**SECTION 00 90 02
BIDDING AND CONTRACT REQUIREMENTS
ADDENDUM NUMBER 2**

Issued: March 7, 2025

Re: ADDENDUM NUMBER (2) TO THE BIDDING DOCUMENTS FOR

**McHenry County College
2024 Health Science Renovations**
Architect's Project Number: 24-032

SHEET TITLE:
FLOOR PLANS

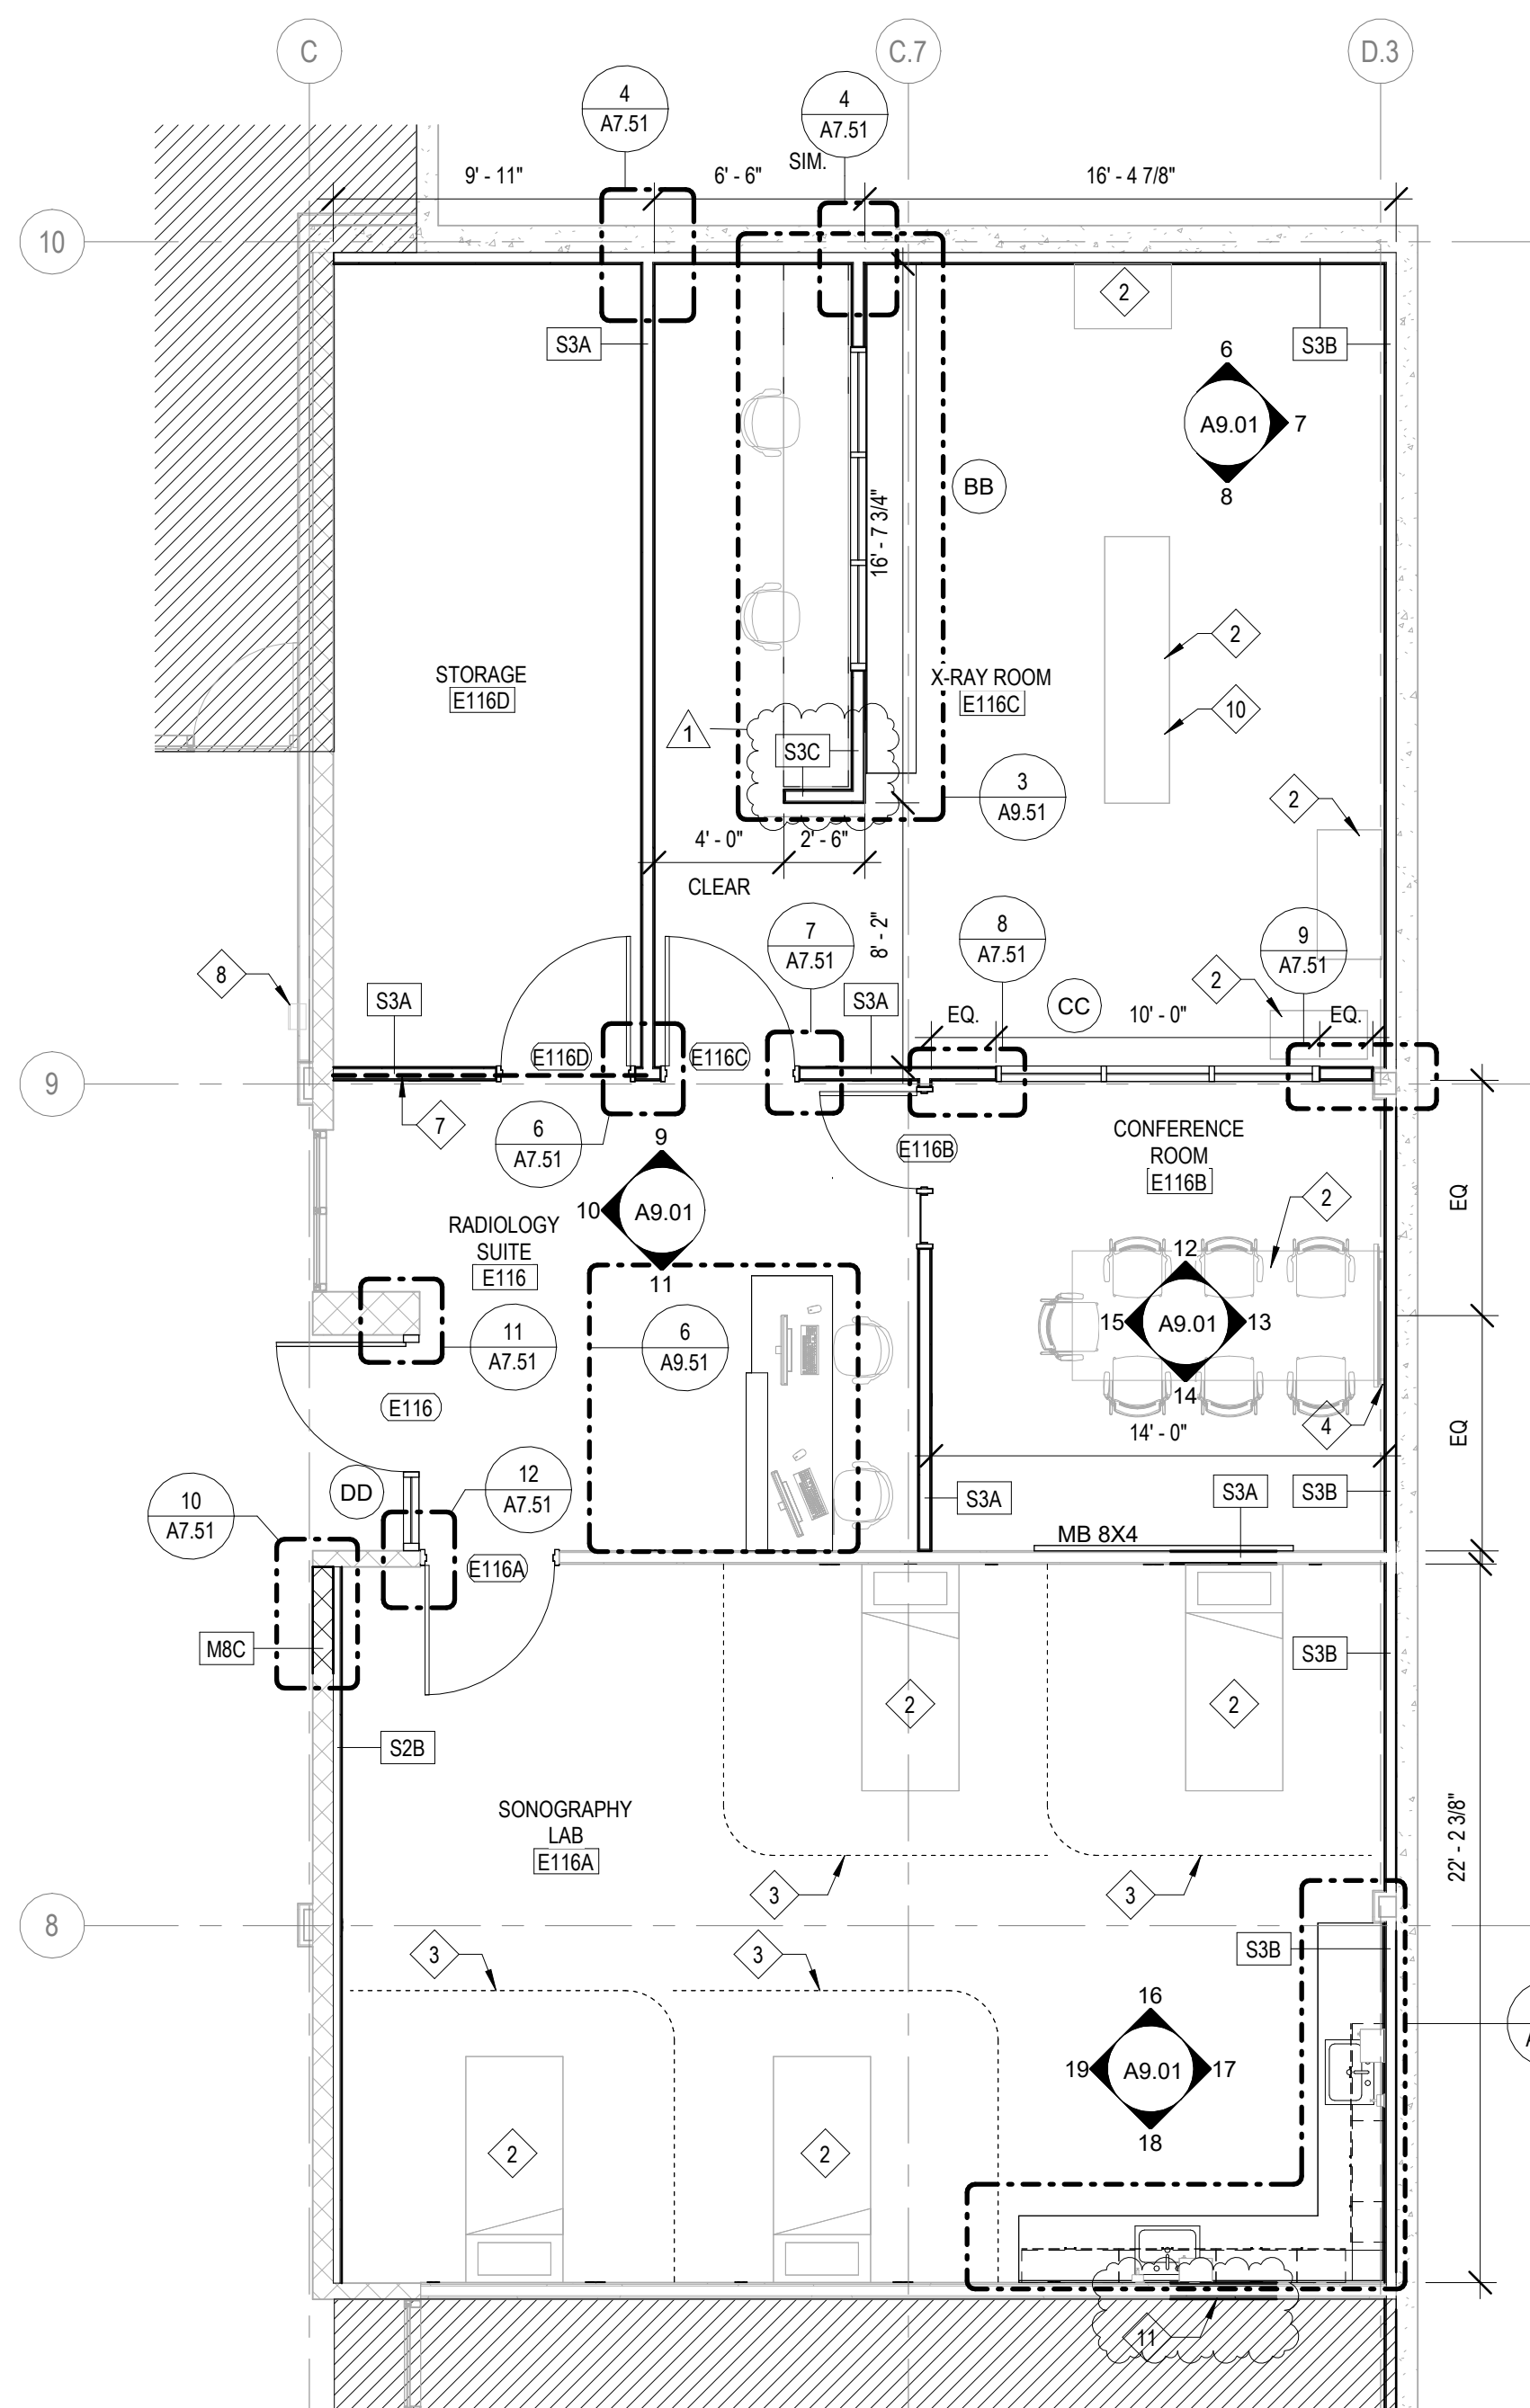
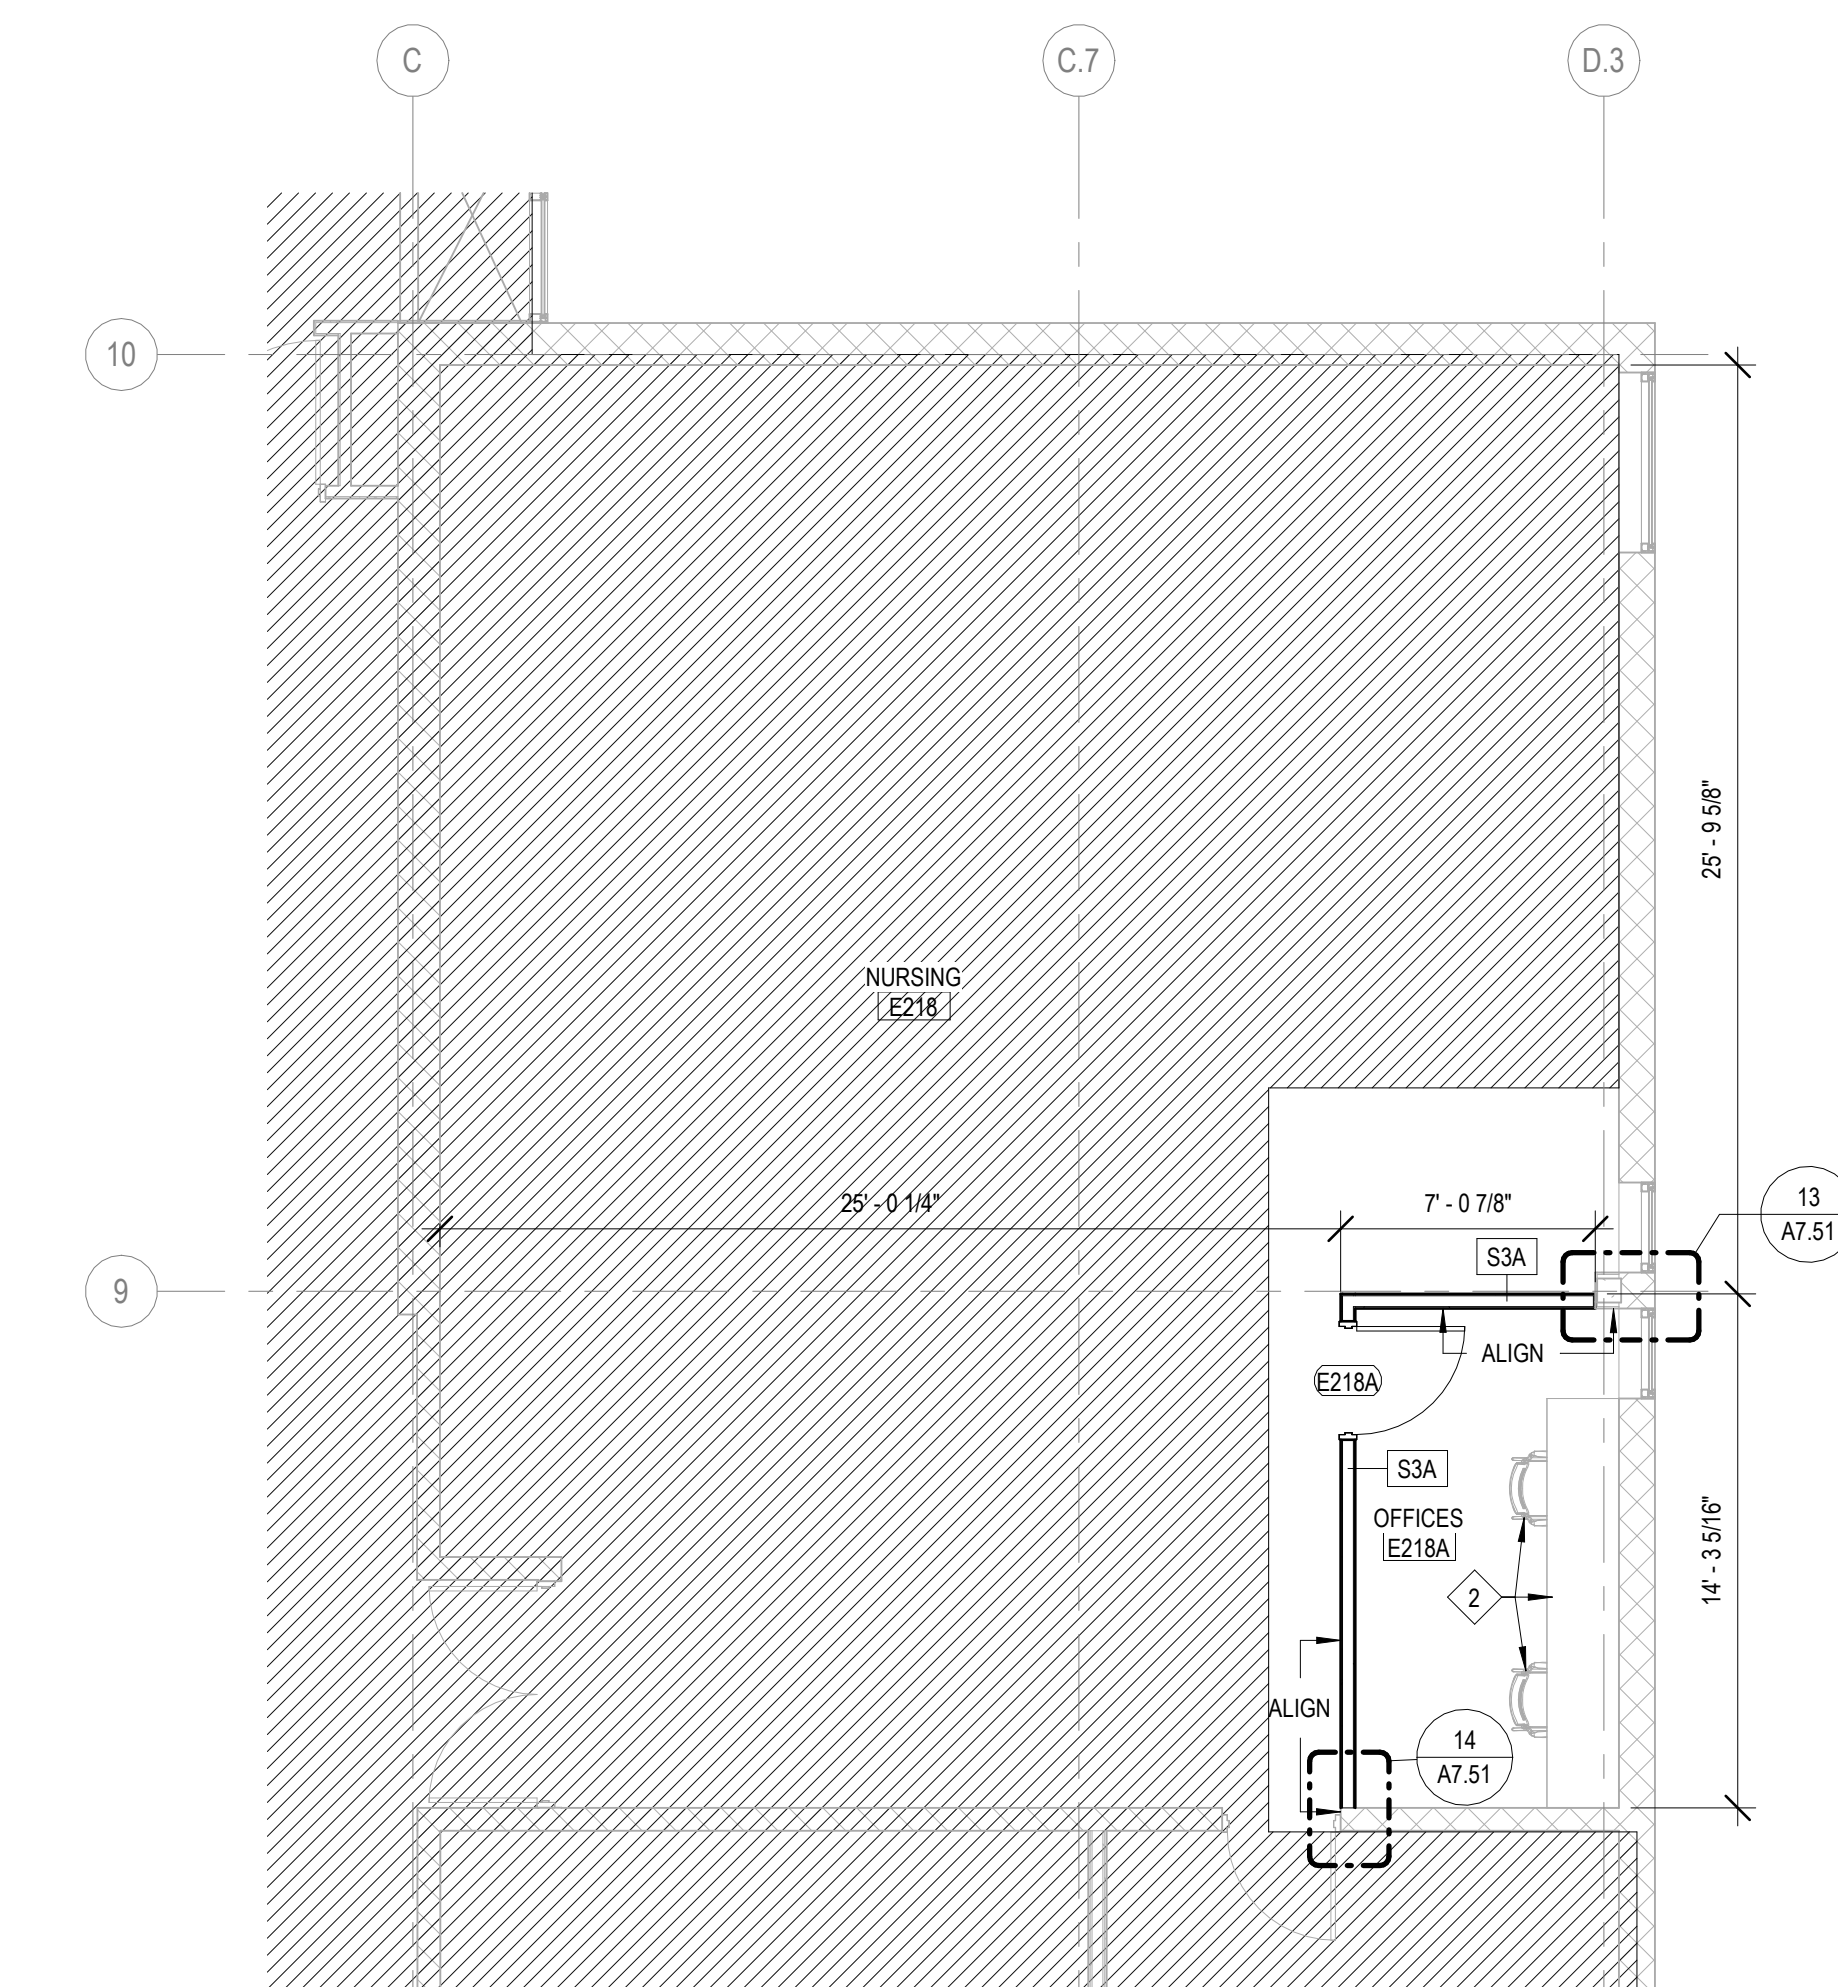
1. A1.10, A10.00
 - a. **REVISE** notes and wall types to clarify extent of lead lined walls required. Refer to RFI responses for additional information.
 - b. **ADD** new work note 11 to clarify wall infill requirements in E116A.

A. RESPONSE: Refer to addendum #2 for wall type clarification.
6. Pre-Bid RFI #5 - (2/A1.10) Floor Plan – Level-1 Radiology calls for wall type S3F, south wall in sonography lab. S3F is not included in wall partition types.

A. RESPONSE: Refer to addendum #2 for wall infill clarification.
7. Pre-Bid RFI #6 - Should the ceilings/ floors/glazing at the X-ray rooms be lead-lined?

- PROVIDE WALL INFILL TO MATCH EXISTING WALL. PER EXISTING DRAWINGS, EXISTING WALL CONSTRUCTION SHOULD BE 3/8" METAL STUD FRAMING WITH (2) LAYERS OF 5/8" GYP BOARD EACH SIDE.
